Docket No. 50-346  
License No. NPF-3  
Serial No. 913  
February 22, 1983

- I. Changes to Davis-Besse Nuclear Power Station Unit 1, Appendix A Technical Specifications 3.3.2.3, 4.3.2.3, Tables 3.3-15, 4.3-15 and Bases.
  - A. Time required to Implement. This change is to be effective upon NRC approval.
  - B. Reason for Change (Facility Change Request 79-283, Rev. B, Supp 3). This amendment request supercedes Toledo Edison submittal of November 15, 1982 (Serial No. 873) and responds to Generic Letter 82-16
  - C. Safety Evaluation (See Attached)

I. Changes to Davis-Besse Nuclear Power Station Unit 1, Appendix A  
Technical Specifications 3.1.2.8, 3.1.2.9, 4.1.2.1 and 4.1.2.2.

FIGURE - 1

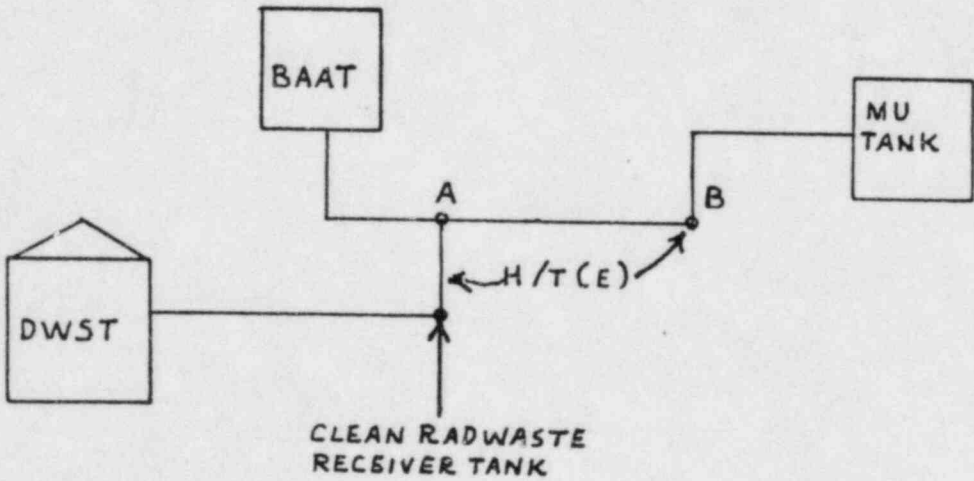
A section of the heat traced piping from the Boric Acid Addition Tank (BAAT) to the "T" connections to the letdown return line is used not only for Boric Acid addition from the BAAT but also is used for the transport of demineralized water and low boron concentration liquid (<5000 ppm) from the clean radwaste receiver tank. When this section of the piping is used for concentration of liquids of less than 5000 ppm boron, the maintainance of piping temperature greater than 105°F is not necessary.

Technical Specifications 4.1.2.1a and 4.1.2.2a should be revised because a section of the heat traced piping from the Boric Acid Addition Tank (BAAT) to the "T" connection to the letdown return line is used not only for boric acid addition from BAAT but also for the transport of demineralized water and other low boron concentration liquid (<5000 ppm) e.g. the clean radwaste receiver tank (see attached Figure 1). The only time that this temperature should be monitored above 105°F is determined by the attached decision tree. The decision tree demonstrates that the only time the need for temperature verification exists is during and after the flow path has been used for transporting fluid with a source concentration of >5000 ppmB. If at any time the line is used for transporting the fluid of source concentration <5000 ppmB the temperature need not be maintained above 105°F. During times when the line is used for transporting a boric acid solution more than 5000 ppmB and after that, the temperature needs to be verified to be more than 105°F. If the fluid source concentration is less than 5000 ppmB, the temperature need not be maintained above 105°F since per the attached graph (Figure 2) the crystallization will occur only below the freezing point of approximately 32°F. Thus, there is no safety concern for boric acid crystallization under those circumstances. Only when the flow path contains high (>5000 ppmB) boric acid concentration does the need for avoiding crystallization exist. Liquid samples are taken from the source for verification of boron concentration (not from the flow path) and this is so reflected in the revised Technical Specifications.

- a. At least once per 7 days by verifying that the pipe temperature of the heat traced portion of the flow path is  $\geq 105^{\circ}\text{F}$ . THIS IS APPLICABLE DURING  
~~when a flow path from the concentrated boric acid storage~~  
~~system is used, and AFTER THIS FLOWPATH IS USED TO TRANSPORT BORIC ACID SOLUTIONS WITH A~~  
~~FLUID SOURCE CONCENTRATION MORE THAN 5000 PPM B UNTIL THE TIME THAT THIS FLOW PATH IS USED FOR~~
- b. At least once per 31 days by verifying that each valve (manual, ANY OTHER PURPOSE.  
power operated or automatic) in the flow path that is not locked, sealed or otherwise secured in position is in its correct position.

- a. At least once per 7 days by verifying that the pipe temperature of the heat traced portion of the flow path from the concentrated boric acid storage system is  $\geq 105^\circ\text{F}$  <sup>THIS IS</sup> ~~APPLICABLE~~  
*DURING AND AFTER THIS FLOW PATH IS USED TO TRANSPORT BORIC ACID SOLUTIONS WITH A FLUID SOURCE CONCENTRATION MORE THAN 5000 PPM B UNTIL THE TIME THAT THIS FLOW PATH IS USED FOR ANY OTHER PURPOSE.*

FIGURE-2

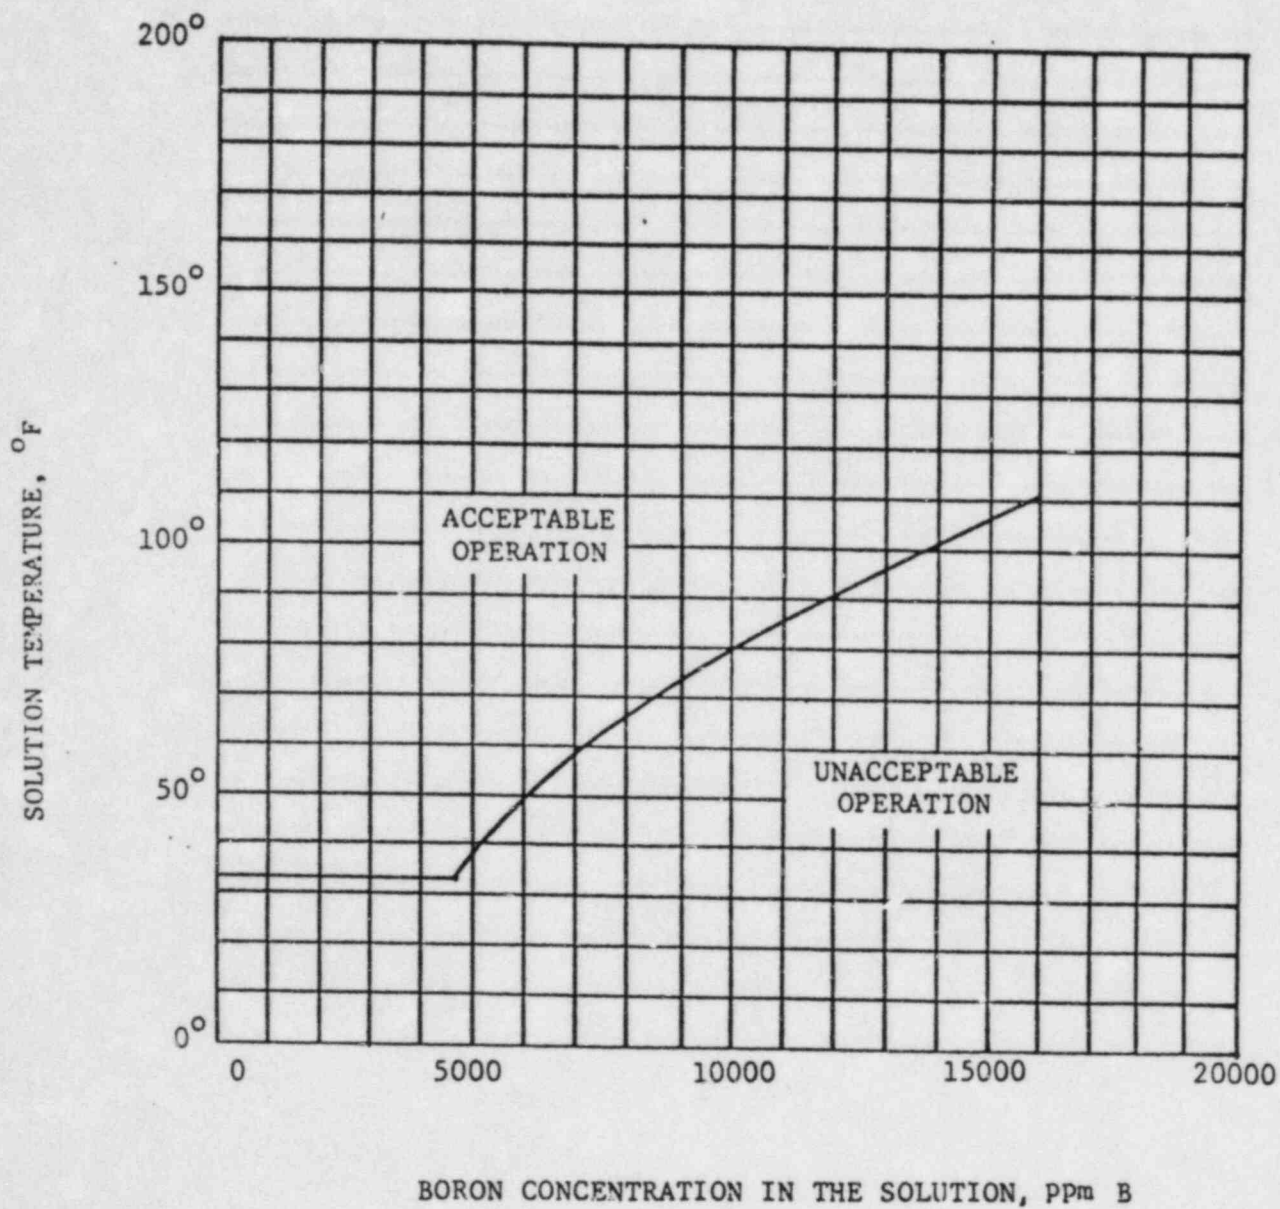
Technical Specifications 3.1.2.8a.3 and 3.1.2.9a.3 require that the boric acid addition system and associated heat tracing have a minimum solution temperature of 105°F. However, revised Technical Specifications 4.1.2.1a and 4.1.2.2a will ensure that the associated heat traced portion of the flow path from the concentrated boric acid storage system is > 105°F when this flow path is used to transport boric acid solutions with a fluid source concentration more than 5000 ppmB until the time that this flow path is used for any other purpose. Therefore, Technical Specifications 3.1.2.8a.3 and 3.1.2.9a.3 should not include the associated heat traced portion since the Surveillance Requirements for its operability are already included in revised Technical Specifications 4.1.2.1a and 4.1.2.2a.

- a. The boric acid addition system ~~and associated heat tracing~~ with:
  - 1. A minimum contained borated water volume in accordance with Figure 3.1-1,
  - 2. Between 7875 and 13,125 ppm of boron, and
  - 3. A minimum solution temperature of 105°F.
- b. The borated water storage tank (BWST) with:
  - 1. A contained borated water volume of between 482,778 and 550,000 gallons,
  - 2. Between 1800 and 2200 ppm of boron, and
  - 3. A minimum solution temperature of 35°F.

- a. A boric acid addition system ~~and associated heat tracing~~ with:
  - 1. A minimum contained borated water volume in accordance with Figure 3.1-1,
  - 2. Between 7875 and 13,125 ppm of boron, and
  - 3. A minimum solution temperature of 105°F.
- b. The borated water storage tank (BWST) with:
  - 1. A minimum contained borated water volume of 70,700 gallons,
  - 2. A minimum boron concentration of 1800 ppm, and
  - 3. A minimum solution temperature of 35°F.
